SERVICE INSTRUCTION

Change of the tightening torque procedure for the installation of cylinder heads for ROTAX® Engine Type 912 i, 912 and 914 (Series)

ATA System: 72-00-00 Engine

Fig. 1

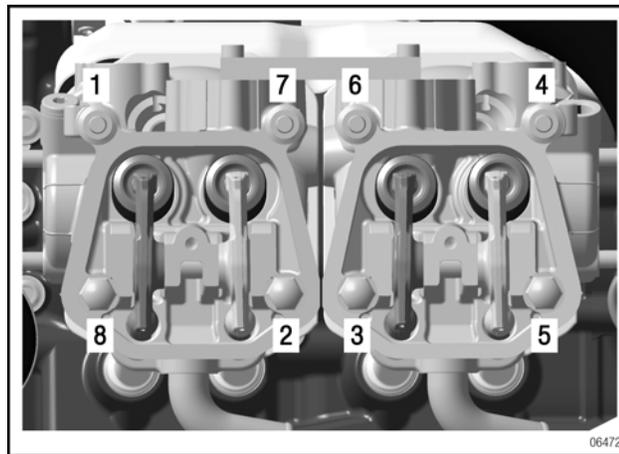
In the course of continuous development a new tightening torque procedure for the installation of the cylinder heads has been introduced.

This new tightening torque procedure results in a more consistent and more durable seal between the cylinder heads and cylinders.

Step	Procedure
1	Raise the cylinder until the centring collar of the cylinder engages in the cylinder head. See latest Maintenance Manual Heavy, chap. 72-00-00.
2	Clean and degrease all threads of studs. NOTE: M8 collar cap and M8 collar nuts also must be clean and free from residues.
3	Lubricate the contact area for the M8 collar cap nuts with grease. NOTE: No grease for M8 collar nuts contact areas!

Step	Procedure
4	Hand-tighten 2 M8 collar cap nuts and 2 M8 collar nuts evenly (maximum 5 Nm/44 in.lb), until cylinder head rests on cylinder.
5	Attach the cylinder aligning tool part no. 877263 to the intake flange of the cylinder heads with 4 M6x25 Allen screws and tighten to 10 Nm (88 in.lb.), see figure 1. NOTE: This aligns the cylinder heads to ensure a flat support for the intake manifold.
6	Tighten the nuts in torque sequence (see figure 2) following these steps: Step 1: all M8 collar cap nuts and M8 collar nuts with 10 Nm (88 in. lb.). Step 2: all M8 collar cap nuts and M8 collar nuts with 30 Nm (-5 Nm)(265 in. lb.) (-44 in. lb). NOTE: Perform step 3 sequentially for each cylinder head nut one at a time following the torque sequence in figure 2. Step 3: Loosen each M8 collar cap nut or M8 collar nut 360° then tighten to 10 Nm (88 in. lb.) + 150°.
7	Loosen 4 Allen screws M6x25 and remove the cylinder aligning tool.

NOTE: The installation and tightening of a single cylinder head or any individual cylinder head nut is not allowed. The entire procedure to torque both cylinder heads together in one torque sequence must be performed.
